LARAMIE COUNTY PLANNING & DEVELOPMENT DEPARTMENT

MEMORANDUM

TITLE: PUBLIC HEARING regarding a Preliminary Development Plan and a Subdivision Permit and Plat for J BAR L Subdivision, for a portion of the NW1/4 SE1/4, Section 24, T.15N., R.65W., of the 6th P.M., Laramie County, WY.

PZ-21-00058(59)

PRELIMINARY DEVELOPMENT
PLAN & LAND ANALYSIS MAP
FOR

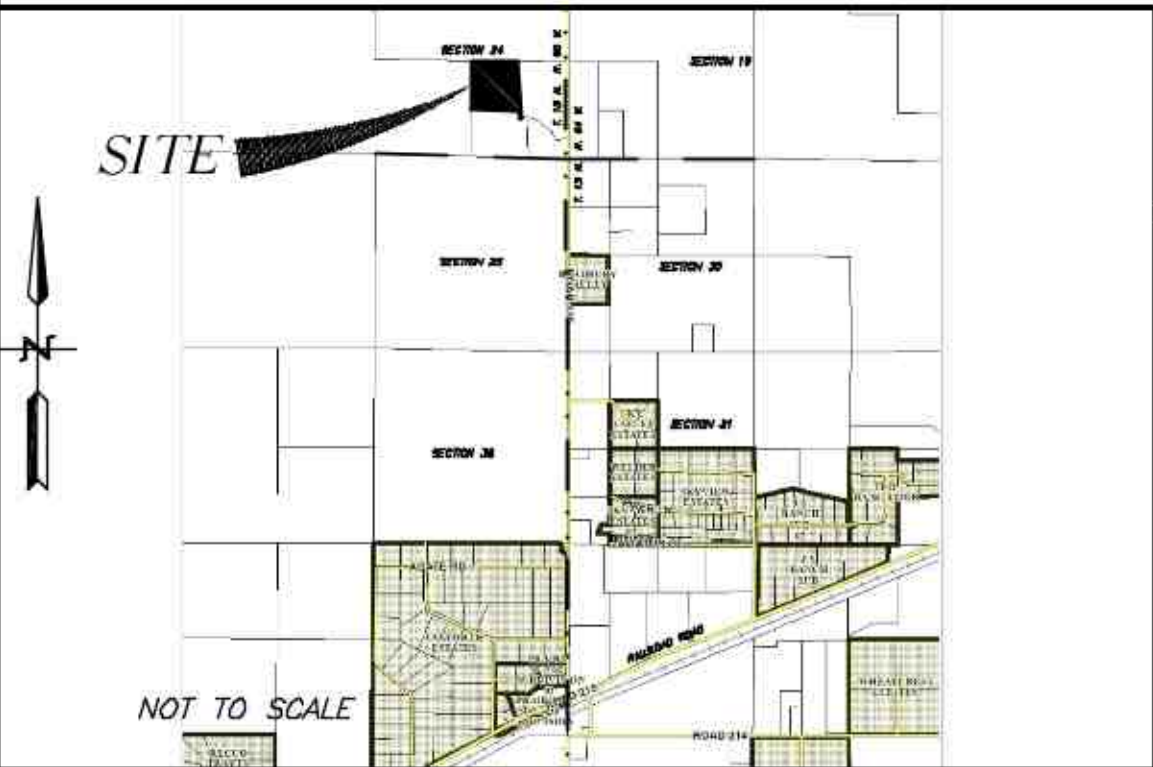
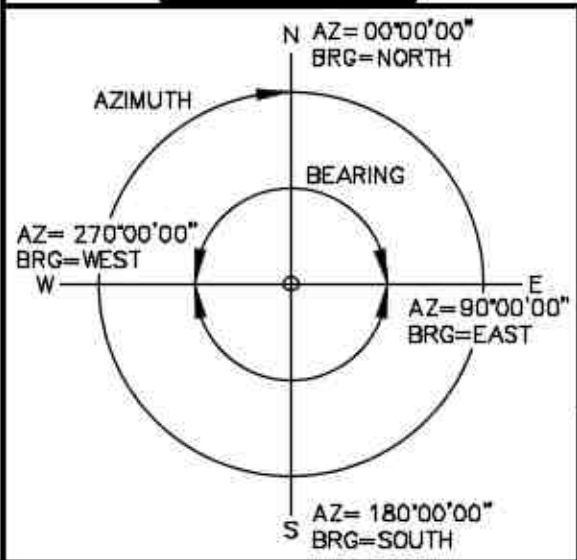
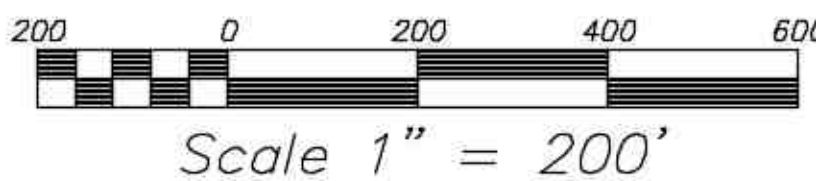
1. The PDP map indicates that the topography and contours are from the Cheyenne & Laramie County GIS but there is no topography/contours shown on the map as required.

2. Although I understand that aerial photography may not exactly line up with the digital information, the existing access road shown on the aerial where it ties into CR136 appears to deviate significantly from the access easement (i.e., the easement shown is very close to being perpendicular to CR136 but the actual existing access curves significantly to the south to tie into CR136). If the actual access road does fall outside of the recorded easement, will the easement be re-established or will the access road be relocated such that it falls within the dedicated easement area?

3. The access roadway from CR136 to the end of the cul-de-sac shall be designed and constructed to meet the current LCLUR. The designs shall be submitted to the County for review and approval.

1. Are the tract acreages net or gross?
2. Note 5 refers to ROW's and access easements being privately maintained. However, I only see an access easement on the plan.
3. The vicinity map is not legible.
4. The existing access does not line up with the proposed subdivisions access easement. How will this be addressed?
5. Surface Drainage, shown by arrows, is not indicated on the map. See County Engineer's comments regarding topography and contours on the map.
6. The land Analysis must state the total buildable are for the development.
7. The present and proposed zoning is included, but the present and proposed land uses are not.

FINAL PLAT
OF
J BAR L SUBDIVISION

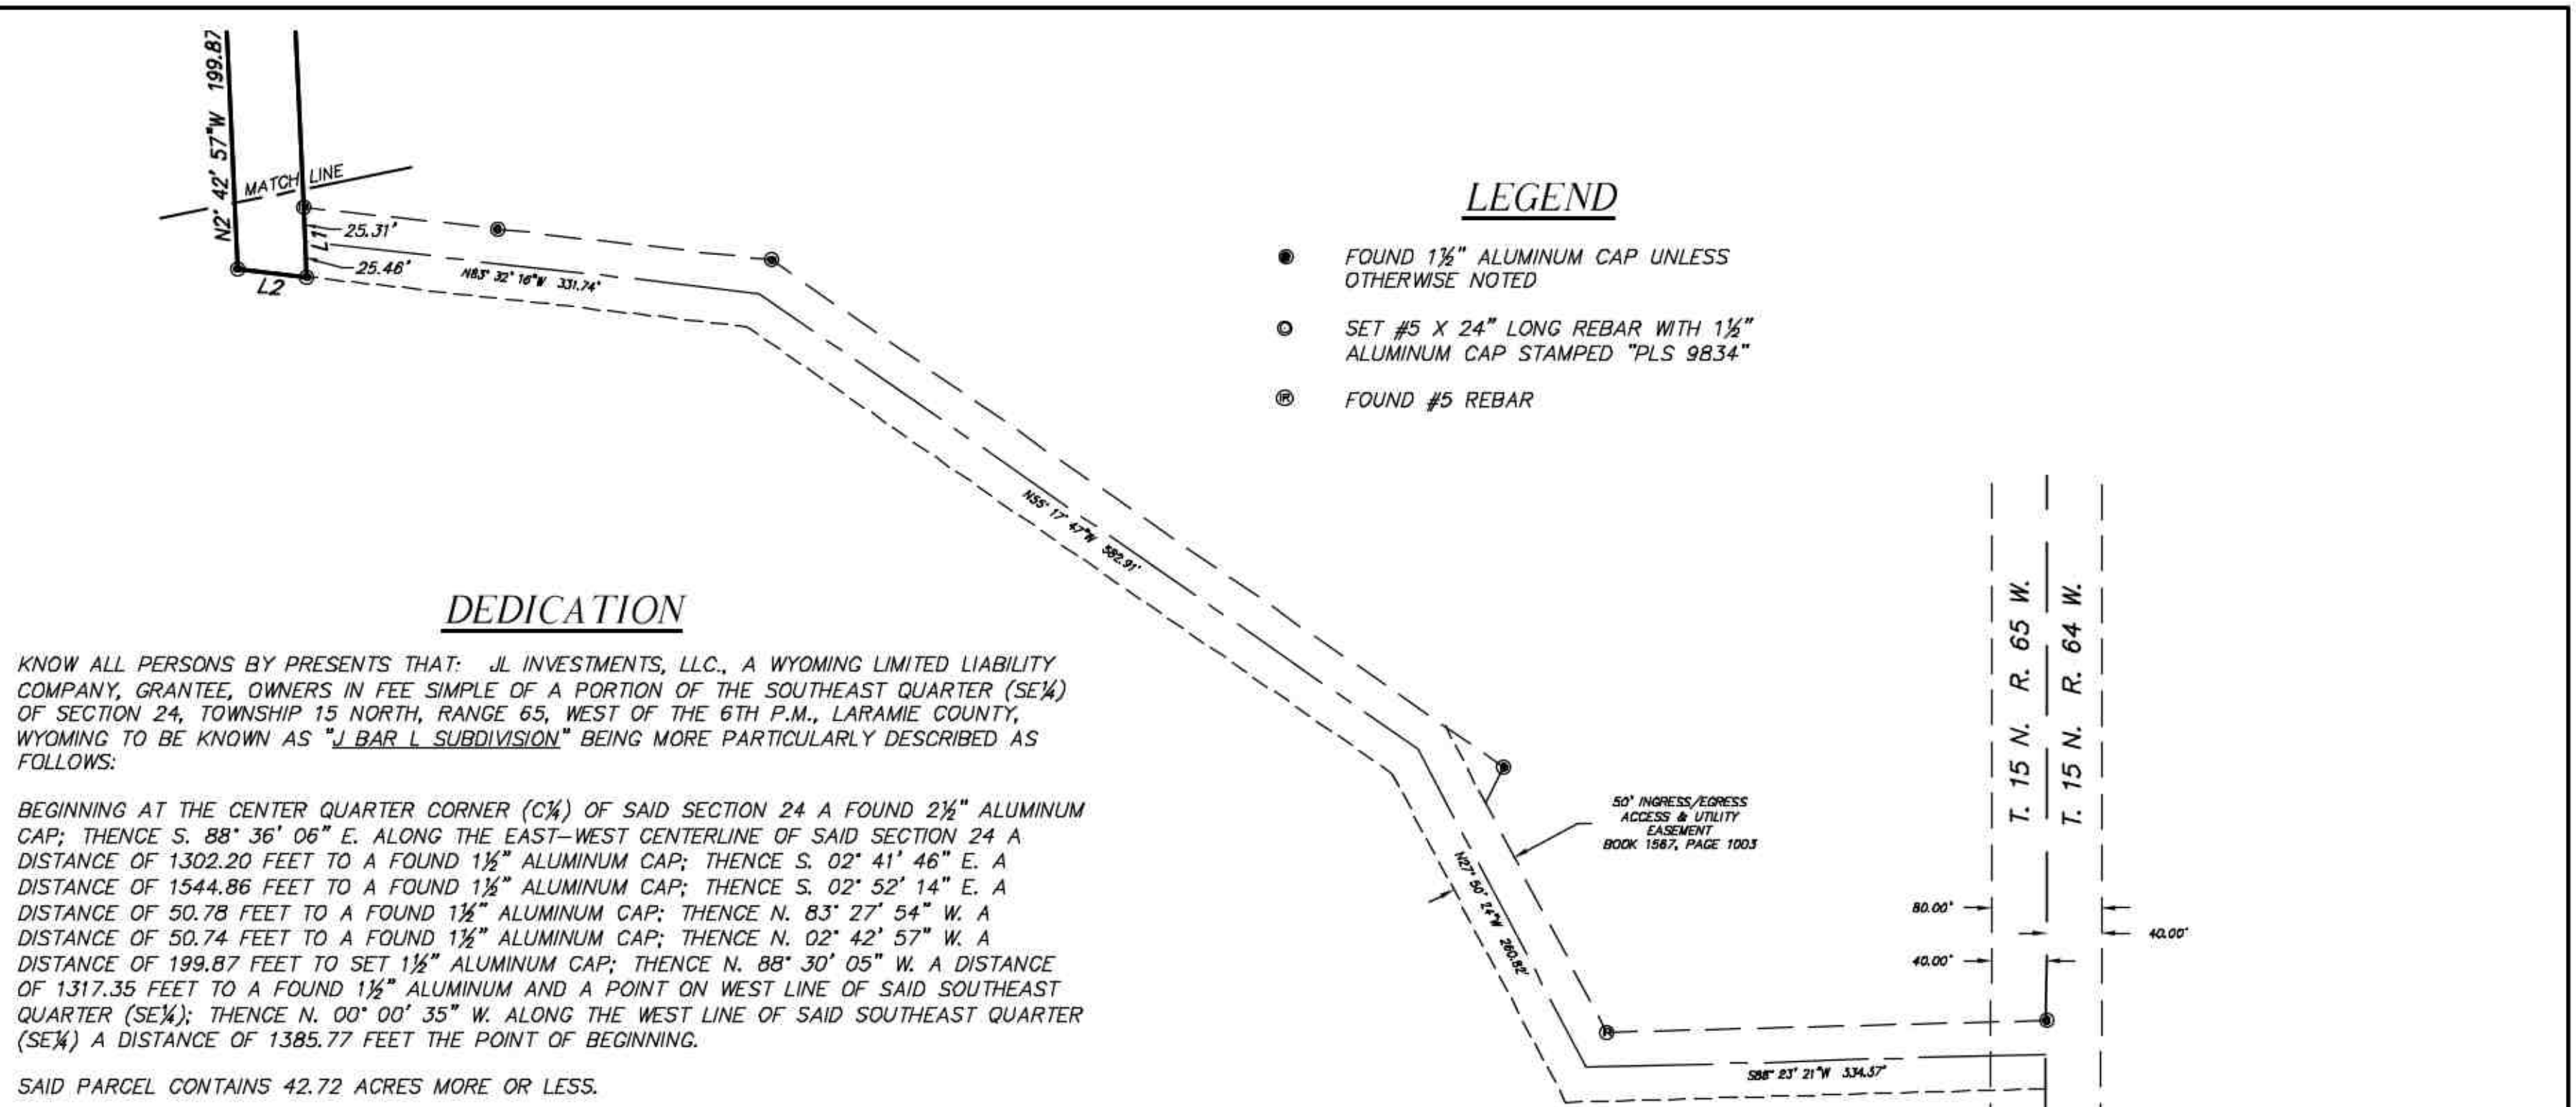
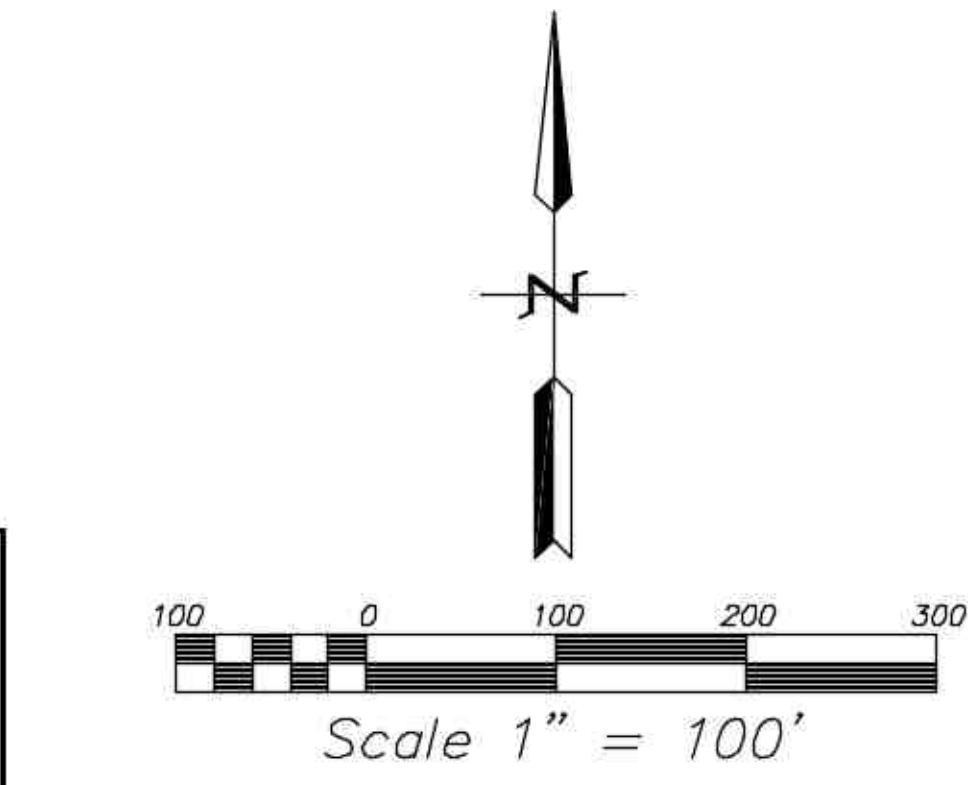
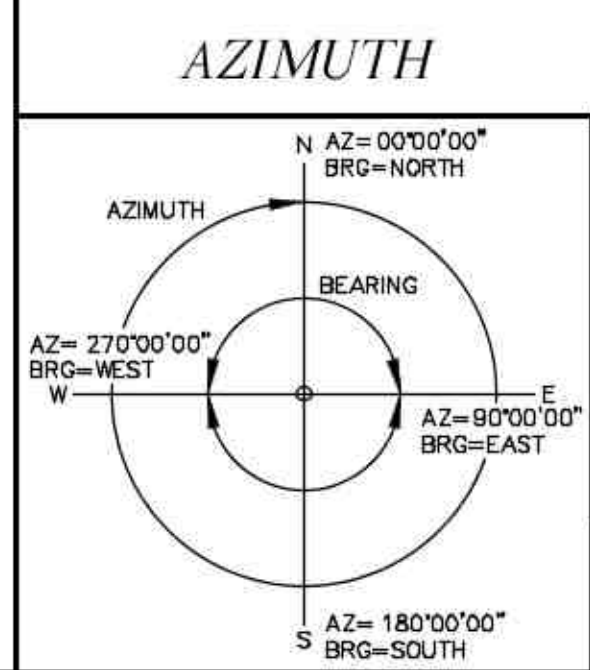
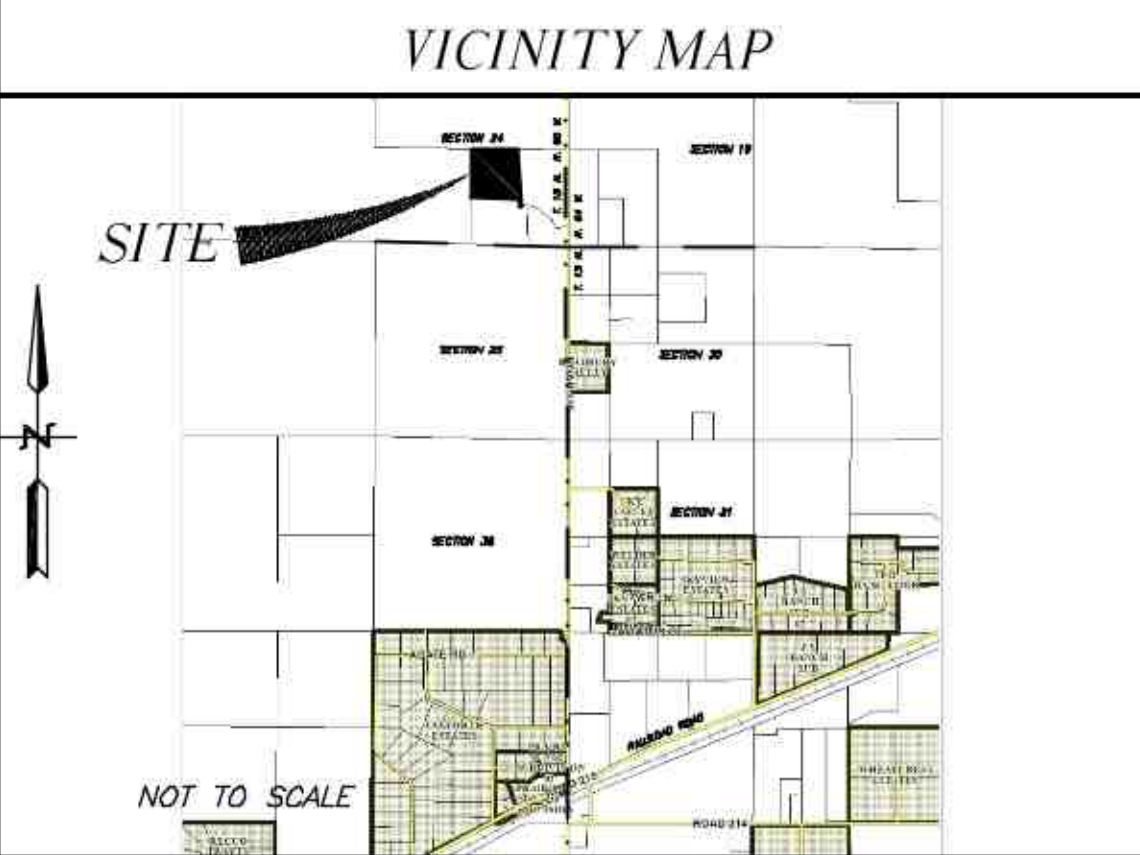
County Assessor: County Assessor, Kaycee Eisele Comments Attached 03/10/2021
APPROVALS AREA, DATE IS STILL MARKED 2020.

1. The year listed under the Approvals are both shown as 2020 which should actually be 2021.
2. I concur with the request for a waiver of a detailed Traffic Study and Drainage Study since this development will have a negligible impact on both.
3. The roadway from CR136 to the end of the cul-de-sac shall be designed and constructed to meet the current LCLUR. The designs shall be submitted to the County for review and approval.

1. The exact location and specifications for the 50' radius curve of the INGRESS/EGRESS ACCESS EASEMENT located in the southwest corner of Tract 1 and the exact location and specifications for the CUL-DE-SAC located at the north end of the INGRESS/EGRESS ACCESS EASEMENT are not completely identified as specified in this section of the regulations.
2. With respect to the 50' INGRESS/ACCESS & UTILITY EASEMENT shown as recorded in Book 1587 on Page 1003, it would be good to include the survey tie to the Southeast Corner of Section 24.
3. Should the 50' INGRESS/EGRESS ACCESS EASEMENTS have road names?
4. Some of the text is pretty small and difficult to read.

1. Are the tract acreages net or gross? I assume they're net due to Note 4, but it is not clear.
2. The vicinity map is not legible.
3. Approval dates must be updated to 2021.
4. See Engineer/Surveyor's comments regarding missing cul-de-sac and radius details. These, along with a curve table, must be shown on the plat per 2-1-101 (e)(xiii)(b).
5. County Road 136 needs to be labeled as just Road 136.
